ACCESSIBILITY AND USABILITY AUDIT REPORT

**INSURANCE REGULATORY AUTHORITY (IRA) ZEP- RE
PLAZA**

REPORT BY: NATIONAL COUNCIL FOR PERSONS WITH DISABILITIES

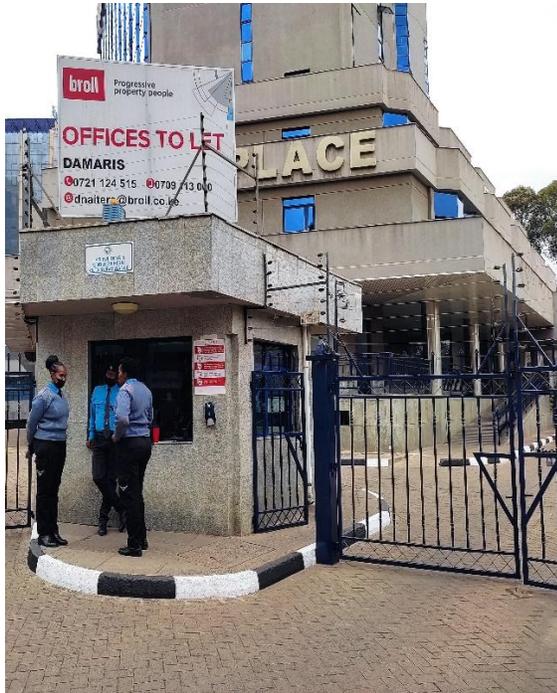
1. During the exercise, the audit team realized that there was a raised Kerb at the pedestrian entrance which is not friendly to wheelchair users.
2. At the main entrance there is no clear signage for IRA logo or wording. The lack of it makes it hard for persons with hearing impairment to access the offices with ease.
3. Security officers at the main gate do not have skills on Kenya Sign Language (KSL) which may be a hindrance to communication especially with those with hearing impairment.

1. The management should put a large signage on the entrance
2. The security guards should be trained on Kenya Sign Language
3. The drop kerb at the pedestrian should be removed to make it accessible for wheelchair users

Reserved Parking at the premises

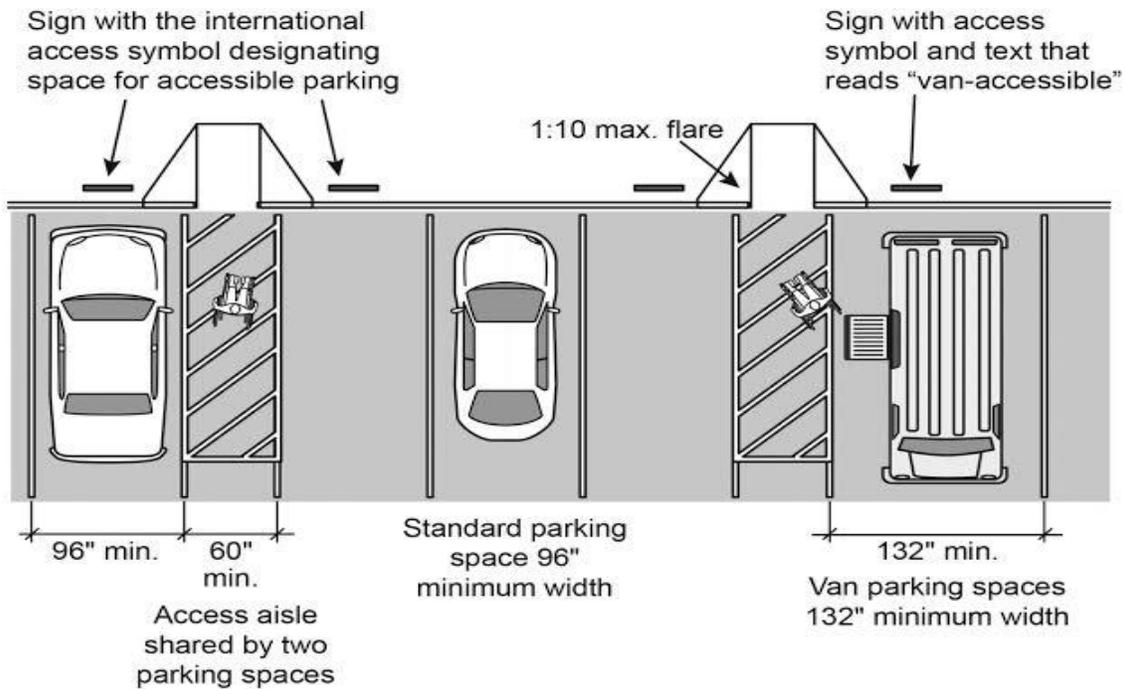
1. Is not accessible since it is not wide enough for persons with disabilities to maneuver and the hand washing area nearby is also an obstruction.
2. The signage should be clearly marked on the floor
3. Currently there is no enforcement on those parking on the reserved parking.

- Designated parking spaces should be located on firm and level ground, as close as is reasonable to the principal accessible entrance to the building with which the parking spaces are associated but no farther than 50meters away from the entrance to the building.
- A parking space designated as one for persons with disability shall have a minimum width of 3.6 m and a minimum length of 4.8 m for perpendicular parking and a minimum length of 6.6 m for parallel parking and with no obstructions.
- Parking spaces shall have an access aisle at least 1500 mm wide along the entire length of the parking space.

Ramp well done hence accessed with ease

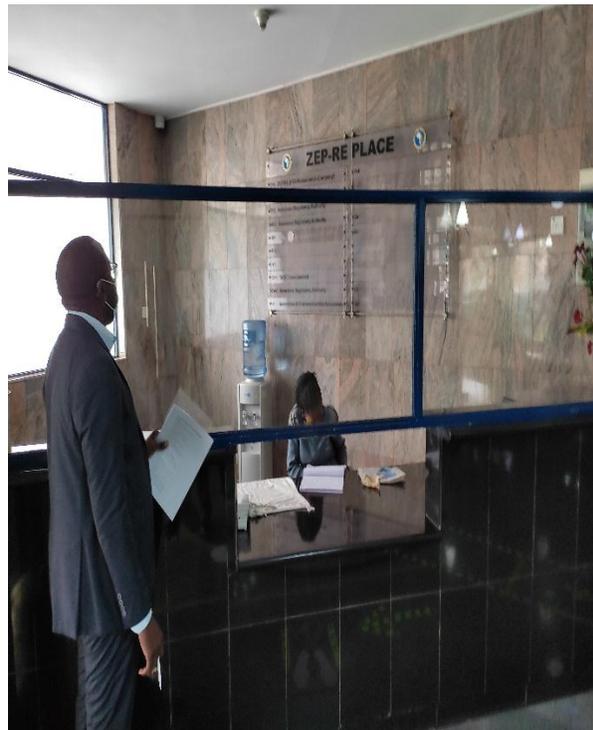
- The ramp has a hand rail on one side which provides proper support for wheelchair and crutches users and it is built on both sides of the entrance of the building.
- The gradient is good hence accessed comfortably by both Persons with Disability and those without disability.

Accessible washroom

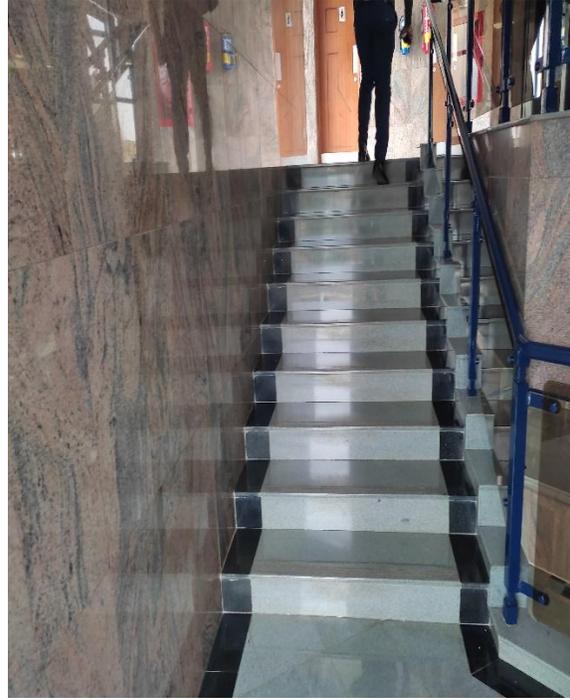
- There is no signage at the corridor leading to the washroom
- The toilet door is well signed.
- The corridor is wide enough but the floor is slippery
- The accessible washroom is good though it does not have a sanitary disposing bin
- The sinks and drier are lowly placed which is useable to persons of short stature and wheelchair users.

- Signage at the corridor leading to the washrooms
- Carpeting of the floor
-
- Place the sanitary disposing bin and we recommend the one with a sensor so that it can be used with those without legs and also those without hands or those who lack both
- The condom dispenser should be placed at a level accessible to persons on wheelchairs and those of short stature

Unfriendly Reception Desk

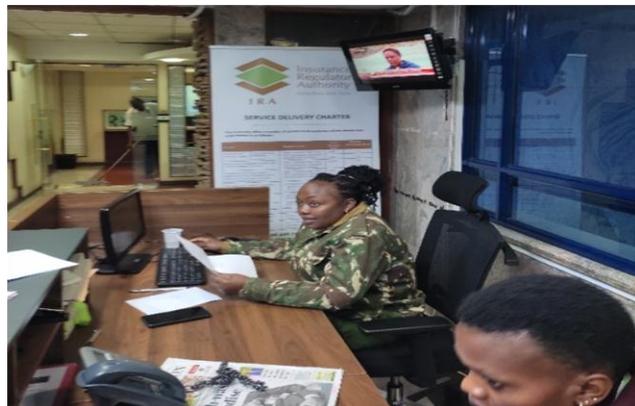
- There is no signage hence making it difficult to identify it.
- Entrance door is made of glass which is not disability friendly
- The reception Counter is highly placed.
- Receptionist not trained on sign language
- Small Tv at the reception with no broadcast on Authority services
- Smooth and Slippery floor
- Limited working space for mobility with a wheel chair
- Poor cabling within the working stations
- Lighting switches highly placed
- Door locks highly placed
- Serving counter at the Records office is highly placed
- The glass at the service counter (records office) also limits sound movement
- The fire alarm has the siren
- Fire alarm lowly placed, friendly for wheelchair users
- Evacuation zone is near the accessible entrance

- We recommend that the Authority to put the signage for ease identification of offices.
- Carpeting of floors to make them friendly for clients and staff using clutches
- Redesign the reception counter
- Larger TV screen at the reception with sound and subtitle on Authority services
- Train reception attendants on Sign language
- Have an accessible washroom

slipery entrance / No signage./Spacious office / splipery centre

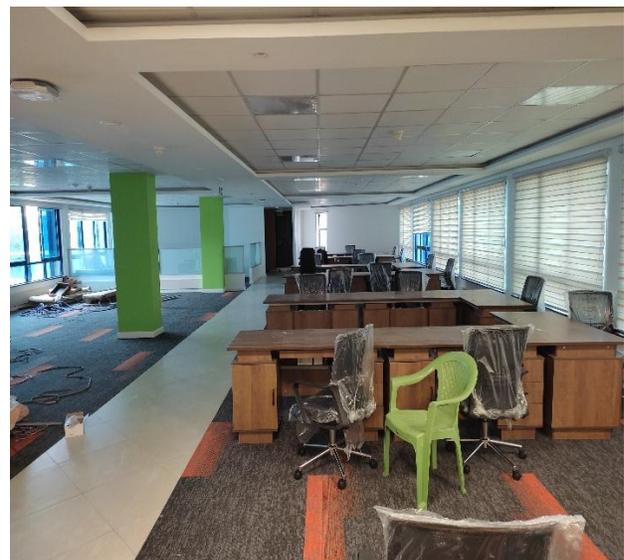
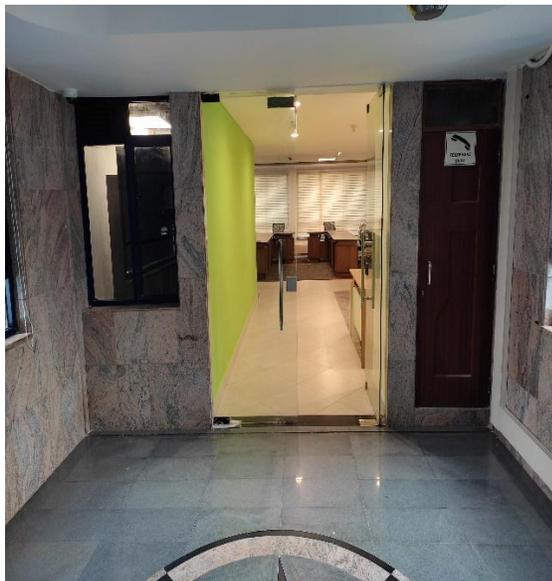
- The floor has a new office which is being set up
- Floor entrance is slippery
- No signage at the entrance
- Door is made of glass which is not friendly
- Highly placed lighting Switches
- Slippery floor at the center

- Good cabling
- Wide doors
- Floor is carpeted
- The chairs are not stable

- The chairs should be firm without rollers at the bottom
- Signage of the entrance
- Non slip floor at the entrance
- Tinting of glass doors to make them visible

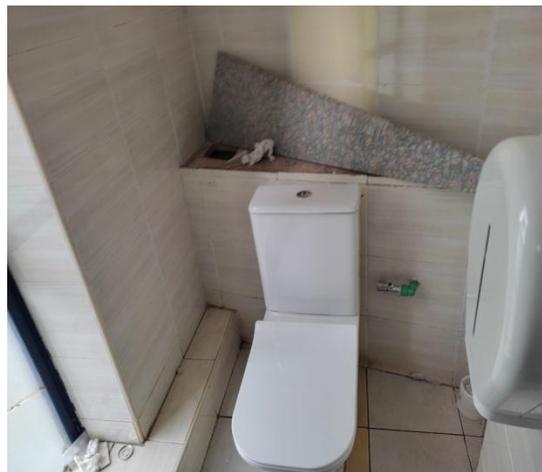
- There are washrooms on all floors for both ladies and gents including none are accessible to PWDs in the upper floors.
- The corridor to the ground floor washrooms is very narrow
- The tissues, hand driers and condom dispensers are highly placed and inaccessible to PWDs.

- There should be an accessible washroom in every floor both for ladies and gents and built in the specifications as per the illustrations for accessible
